URGENT: VOLUNTARY MEDICAL DEVICE CORRECTION

O-arm™ O2 Imaging System Detector Panel Firmware Update

20 Tháng Năm 2026 | 03:43 CDT

Figure 1. Example of ASIC image artifacts. (a) 2D scan with rectangular artifact (b) 3D Scan with ring artifact

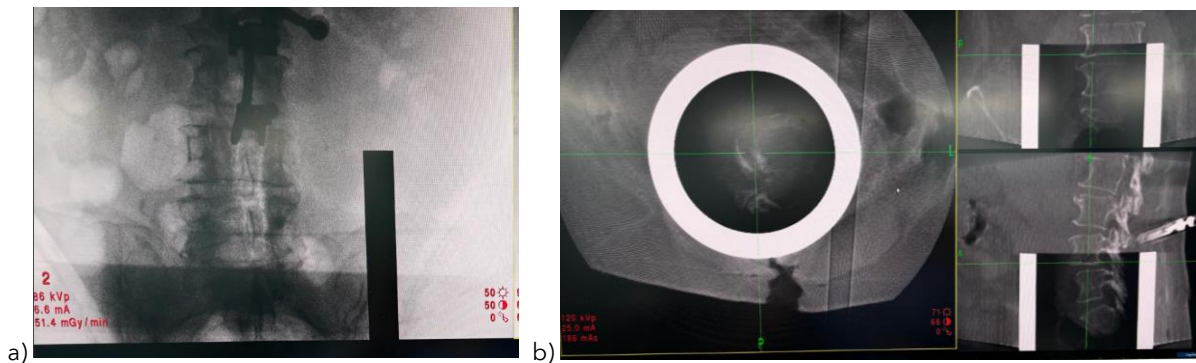
Medtronic has identified the potential for image artifacts caused by an anomaly in the O-arm O2 Imaging System's detector panel firmware.

The issue presents as an artifact in both 2D and 3D images and can be resolved by power cycling (rebooting) the system. If the artifact is present in a 2D image and the user proceeds to a 3D scan without rebooting the system, the artifact will persist in the 3D images as shown in the images in Figure 1 below.

The purpose of this letter is to advise you that Medtronic is implementing an update to the firmware of the detector panel of the O-arm™ O2 Imaging System (O2) serial numbers listed in Appendix A of this notification. You may continue use of the system prior to the service visit by Medtronic to update the firmware. The issue is intermittent and may not present, however if it does it can be resolved by power cycling (rebooting) the system.
